CITY of NOVI CITY COUNCIL

Agenda Item 4
April 18, 2016

SUBJECT: Consideration for approval of the request of Learning Care Academy (aka Everbrook Academy), JSP15-57, for a Planned Suburban Low-Rise (PSLR) Overlay Development Agreement and revised Concept Plan. The subject property is 4.15 acres of vacant land located on the west side of Beck Road, north of Eleven Mile Road, in Section 17. The applicant is proposing a child care facility to serve up to 138 children.

JSP 15-57 Learning Care Academy

Previously submitted and approved CONCEPT PLAN documents

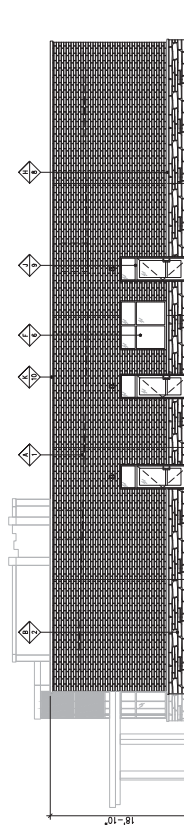
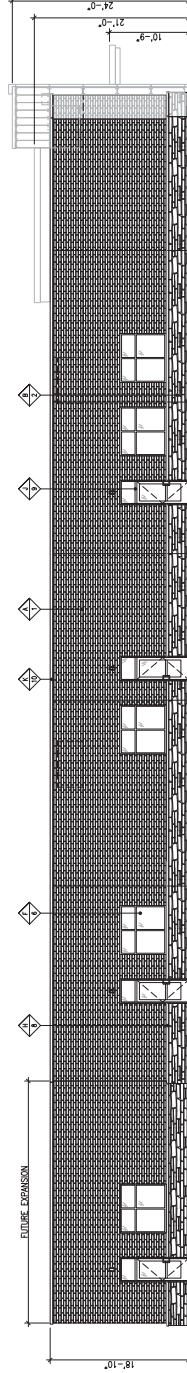
- Reconfiguration of the playground area.
- Elimination of the building expansion area.
- Deletion of (8) parking spaces to reflect no expansion of the building.
- Addition of a taper along Beck Road at north drive as recommended by Traffic Analysis, which will be provided as part of the Preliminary Plan Submittal.
- Revision to the turnaround design for the east/west road per City comments.

- Elimination of the building expansion area.
- Reduction of the canopy feature at main entrance.
- Relocation of building signage from canopy to building wall.
- Change of material along building base from stone veneer to full depth block.
- Change of material/color on entrance feature from Trespa Meteon Wood to Nichica Vintage Wood.

RIGHT (NORTH) SIDE ELEVATION

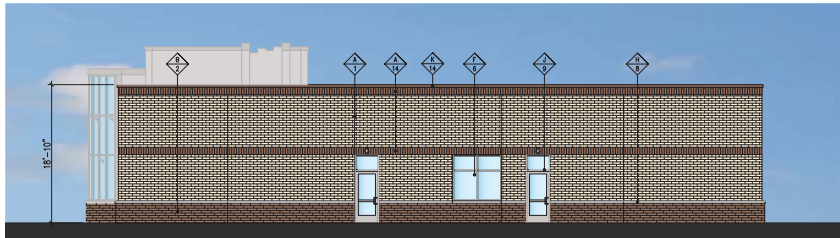
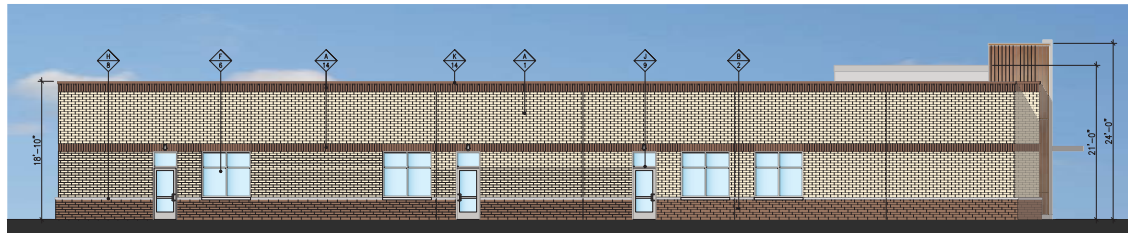
7. **Facade review:** The façade review letter has been updated to reflect the revised Concept Plan, and states the proposed building design is in full compliance with respect to building materials. The review notes that the building is commercial in nature, and does not meet the single family residential characteristics typically expected of the Planned Suburban Low Rise ordinance (i.e., sloped roofs with gables, hips, dormers, overhangs, shingles and gutters).
